NOTICE OF VIOLATION

INSPECTION REPORT

Electrical Corporation:	PacifiCorp (PC)
Report Number:	PC_CAC17_20240501_1051
Inspector:	CAC17
WMP Year Inspected:	2023
Quarterly Data Report (QDR) Referenced:	Quarter 4 (Q4)
Inspection Selection:	Energy Safety viewed the contents of the Q4 QDR and performed an analysis that resulted in the selection of the WMP initiatives and locations referenced in this report.
Relevant WMP Initiative(s):	Distribution Pole Replacements and Reinforcements (2023 WMP initiative number 8.1.2.3)
Date of inspection:	May 1, 2024
City and/or County of Inspection:	Weed, Siskiyou County
Inspection Purpose:	Assess the accuracy of PacifiCorp’s QDR data, completeness of its work, compliance with WMP requirements, and compliance with its protocols.

Violation 1

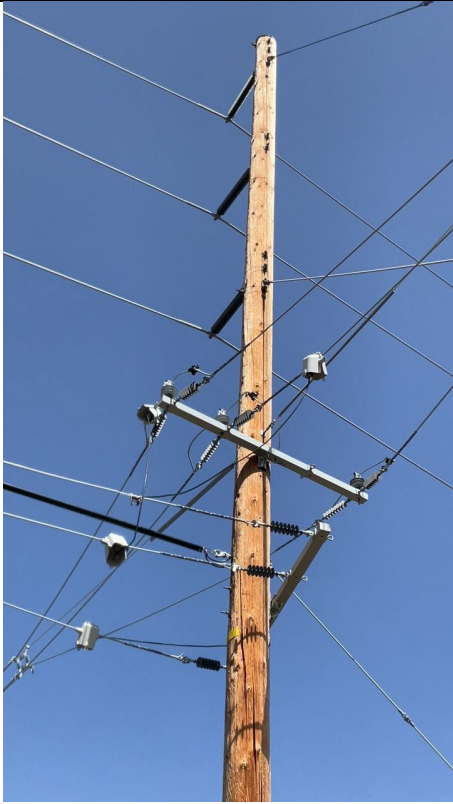
On pole ID 06242005.0177461 at 22602 Slough Rd, Weed, CA, 96094, USA, 41.4857664462249, -122.442510294584, the inspector observed that the subject pole was a wood pole, manufactured in the year 2006. The inspector's observation is documented in Violation 1 photographs, which are attachments to this report. Photo numbers Item13GImg1, Item13GImg2, Item13IA1Img3, and Item13IA1Img4 depict that the pole was not replaced.

1. PacifiCorp's WMP Distribution Pole Replacement initiative (8.1.2.3) work was identified as complete at this location.
2. The subject pole was not recently replaced.
